HISTORIC AND DESIGN REVIEW COMMISSION

HDRC CASE NO: 2019-074
ADDRESS: 413 CLUB DR
LEGAL DESCRIPTION: NCB 7014 BLK LOT W 35 FT OF 4 & E 16.5 FT OF 5
ZONING: RM-4, H
CITY COUNCIL DIST.: 7
DISTRICT: Monticello Park Historic District
APPLICANT: Ramiro Reyes
OWNER: Ramiro Reyes
TYPE OF WORK: Window replacement, exterior painting
APPLICATION RECEIVED: February 14, 2019
60-DAY REVIEW: April 13, 2019
REQUEST:

1. Replace 33 wood windows with vinyl windows.
2. Install wood window screens.
3. Paint the exterior of the building.

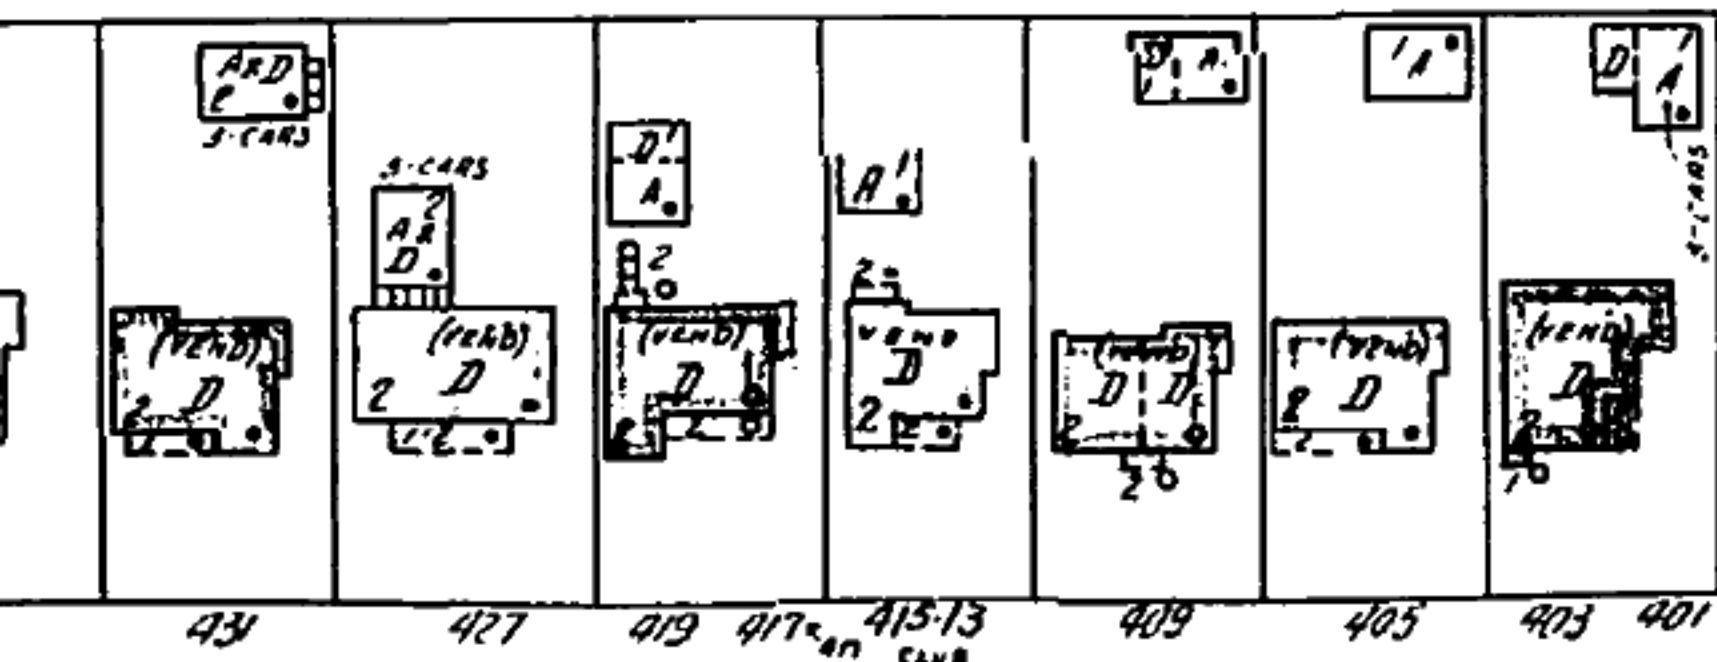
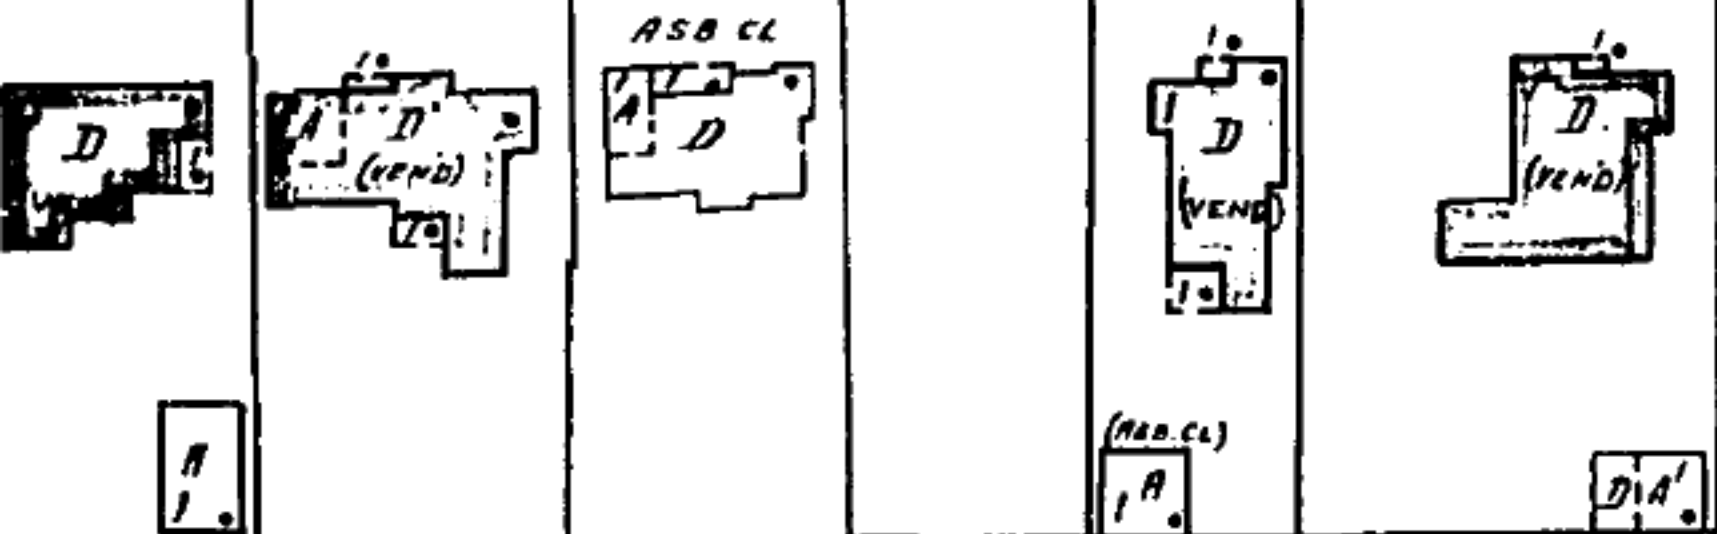
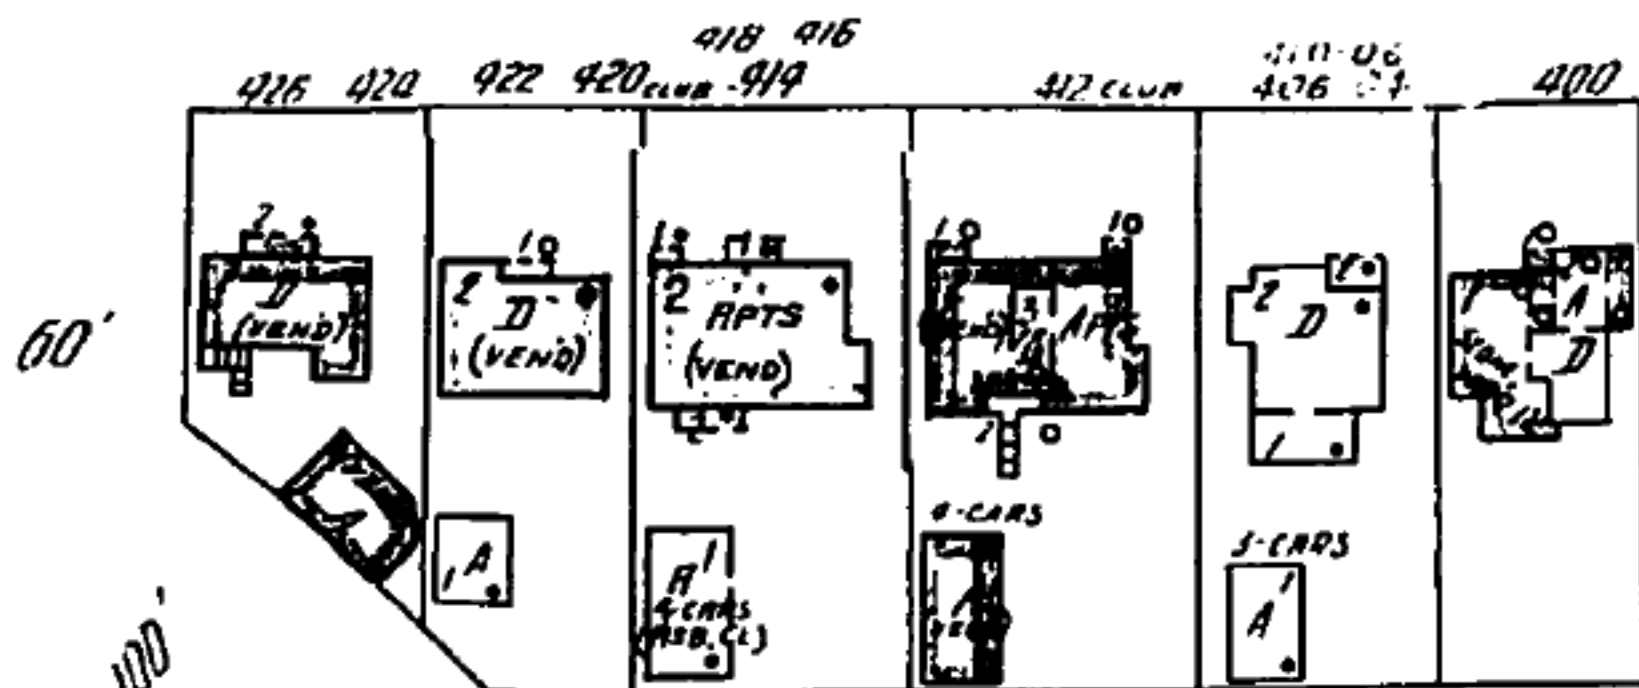
- d. **WINDOW REPLACEMENT** – The applicant has proposed to replace 33 wood windows with vinyl windows throughout the structure. The Guidelines for Exterior Maintenance and Alterations 6.B.iv. notes that window replacement should only be considered when the original windows are deteriorated beyond repair. Staff finds that the windows are character-defining features of the property and can potentially be repaired. The proposed replacement is not consistent with the Guidelines.

- e. **NEW WINDOWS** – The applicant has proposed to install white, single hung vinyl windows. The Guidelines for Exterior Maintenance and Alterations 6.B.iv. notes that new windows are to match the historic or existing windows in terms of size, type, configuration, material, form, appearance, and details. Staff finds that the proposed windows are not compatible in style or materials with the original windows. New replacement windows if approved should feature the following specifications: *Meeting rails that are no taller than 1.25” and stiles no wider than 2.25”. White manufacturer’s color is not allowed, and color selection must be presented to staff. There should be a minimum of two inches in depth between the front face of the window trim and the front face of the top window sash. This must be accomplished by recessing the window sufficiently within the opening or with the installation of additional window trim to add thickness. Window trim must feature traditional dimensions and an architecturally appropriate sill detail. Window track components must be painted to match the window trim or concealed by a wood window screen set within the opening.*

- f. **WINDOW SCREENS** – The applicant has proposed to install wood window screens. Per the Guidelines for Exterior Maintenance and Alterations 6.B.i.x., wood screen window frames should match in profile, size, and design of those historically found when the existing screens are deteriorated beyond repair; the tint of replacement screens should closely match the original screens or those used historically. Staff finds that the proposed window screens are generally consistent with Guidelines.

- i. Staff does not recommend approval of window replacement based on findings b through j. If the original wood windows have been permanently discarded, and the commission is compelled to approve window replacement, then staff stipulates that new wood or aluminum-clad wood windows are submitted to staff with the standard specifications: *Meeting rails that are no taller than 1.25” and stiles no wider than 2.25”. White manufacturer’s color is not allowed, and color selection must be presented to staff. There should be a minimum of two inches in depth between the front face of the window trim and the front face of the top window sash. This must be accomplished by recessing the window sufficiently within the opening or with the installation of additional window trim to add thickness. Window trim must feature traditional dimensions and an architecturally appropriate sill detail. Window track components must be painted to match the window trim or concealed by a wood window screen set within the opening.*

- ii. Staff recommends approval of the installation of wood window screens based on finding j.
- iii. Staff recommends approval of exterior painting only on wood elements based on findings k; no masonry should be painted.
